FINAL DRAFT MINUTES

September 19, 2013 Standards Committee Meeting

RE: Minutes from the September 19, 2013 Standards Committee Meeting

1. APPROVAL OF THE MINUTES FROM THE JUNE 20, 2013 MEETING.
PROPOSED REVISION TO ITEM 04 (WITH MARKUPS).

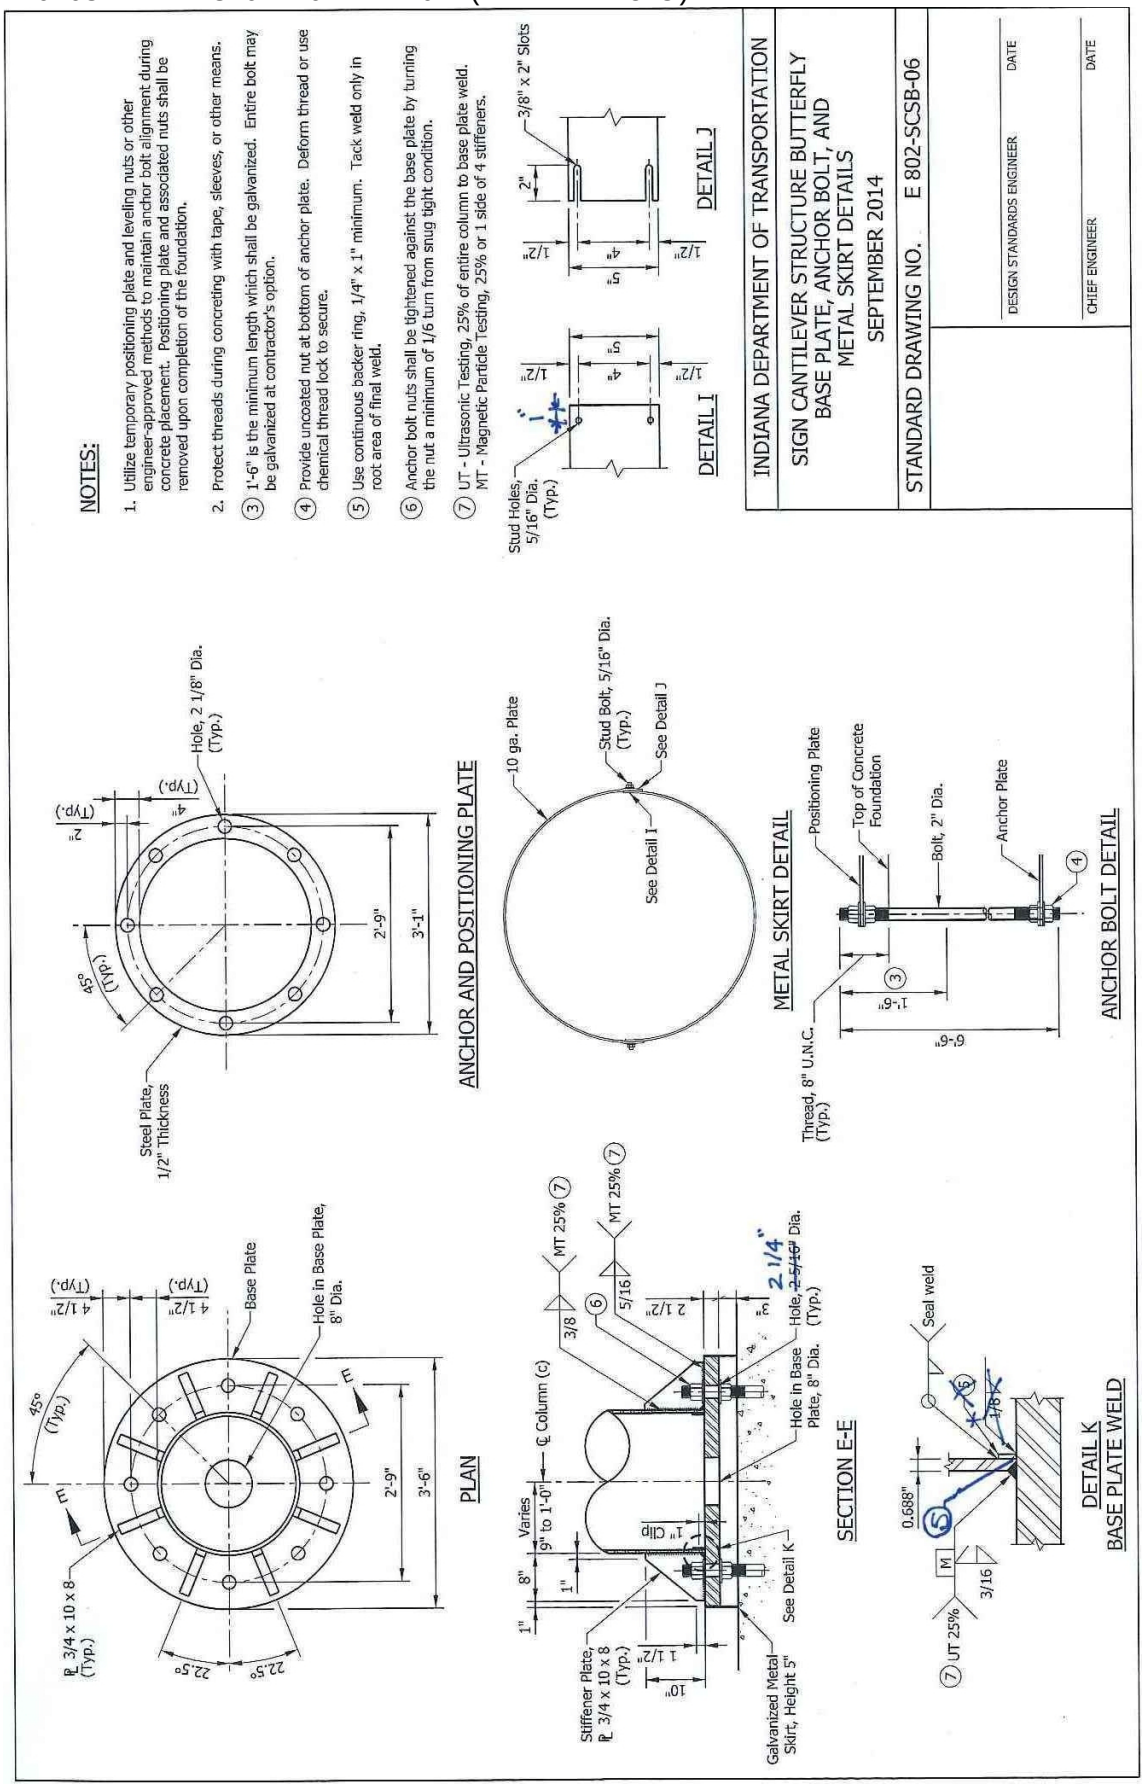
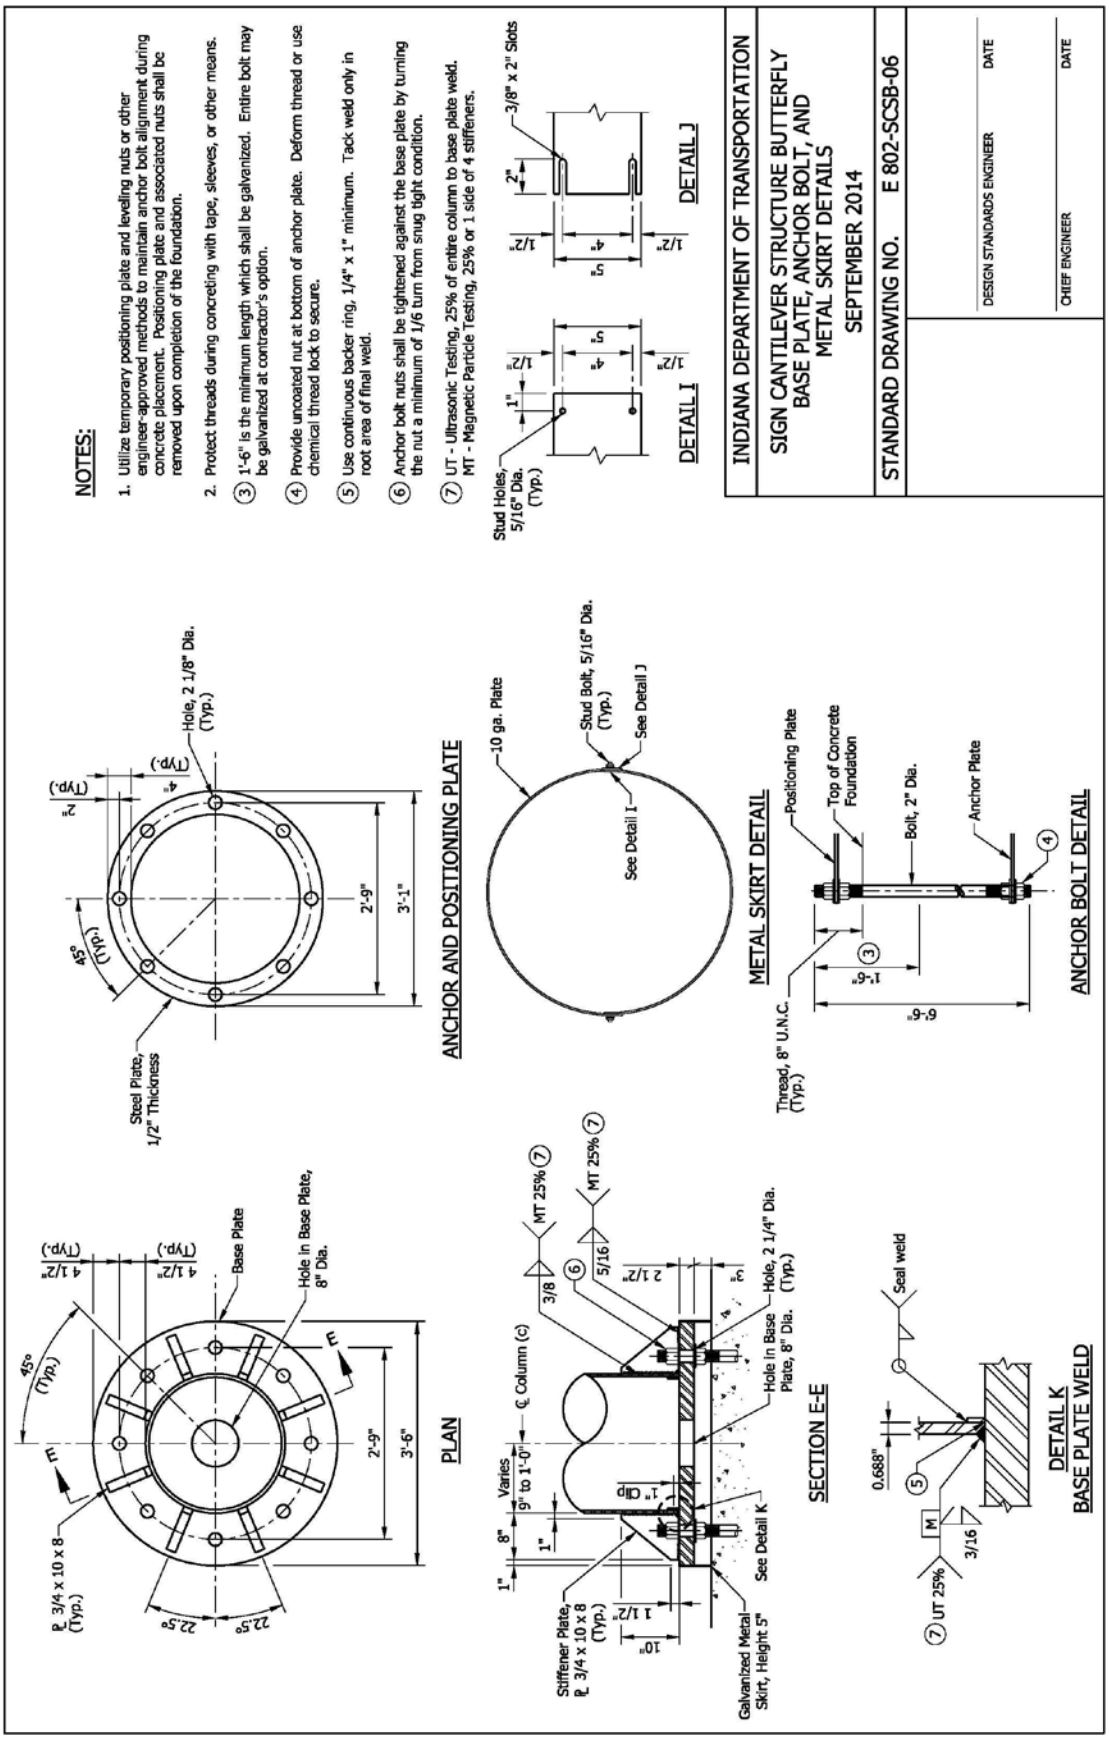
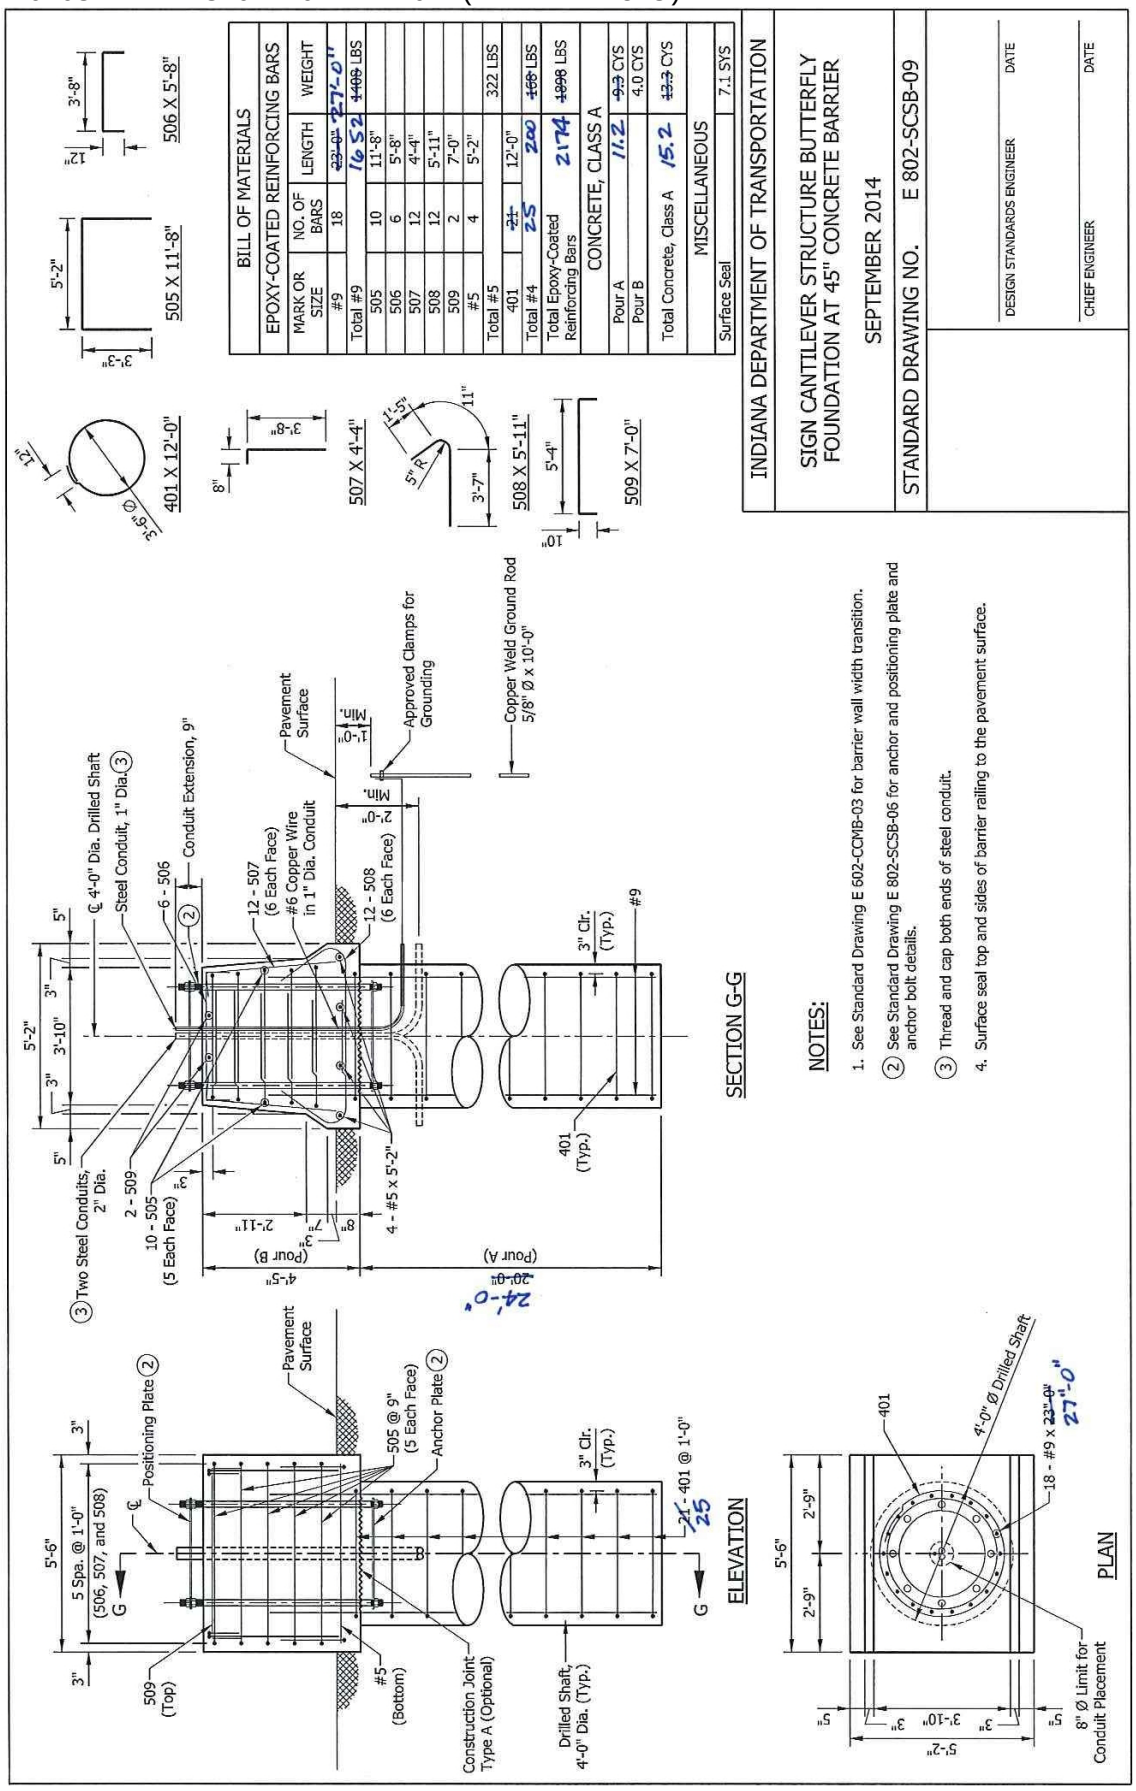
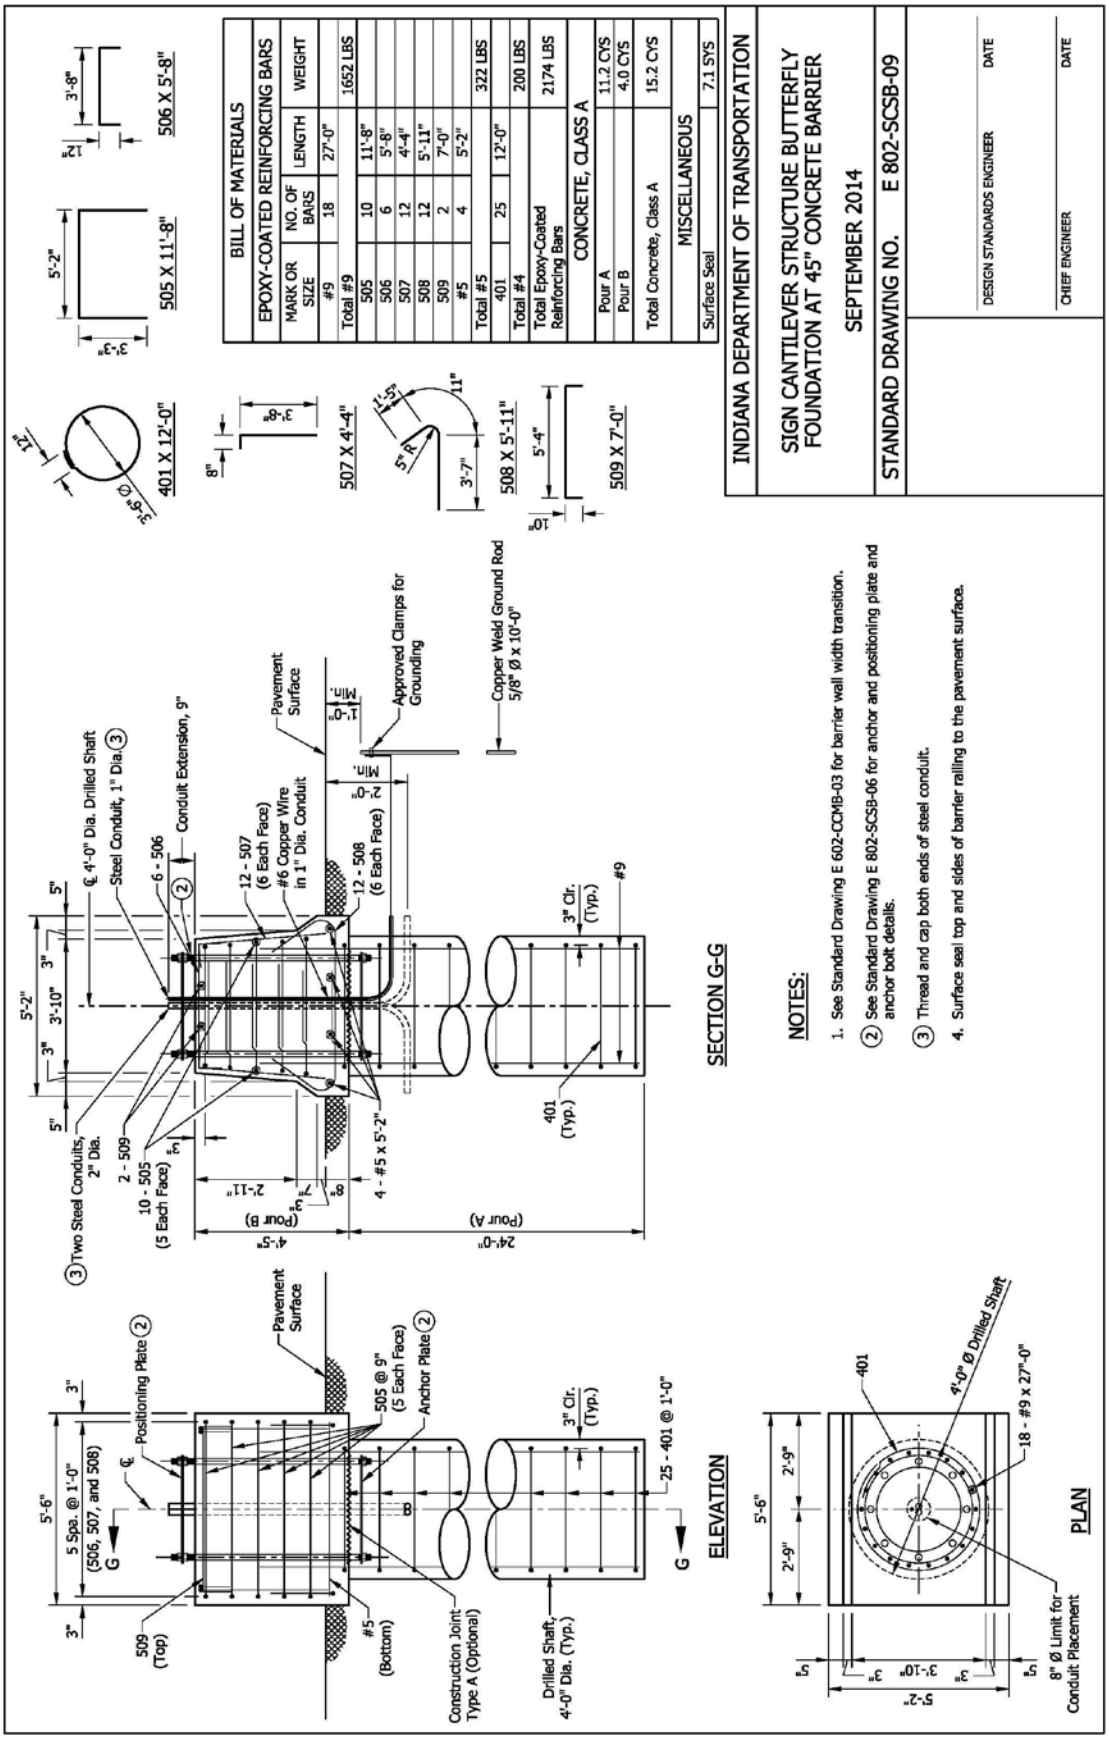
DISCUSSION: Mr. Miller requested a motion to accept the minutes from the last meeting, as revised by Mr. Hanza. Mr. Boruff and Mr. Hanza briefly explained the revisions made to the attached drawings (pg 4 thru 7). Mr. Buening also requested a revision to RSP 401-R-581 concerning the joint adhesive temperature range to read:
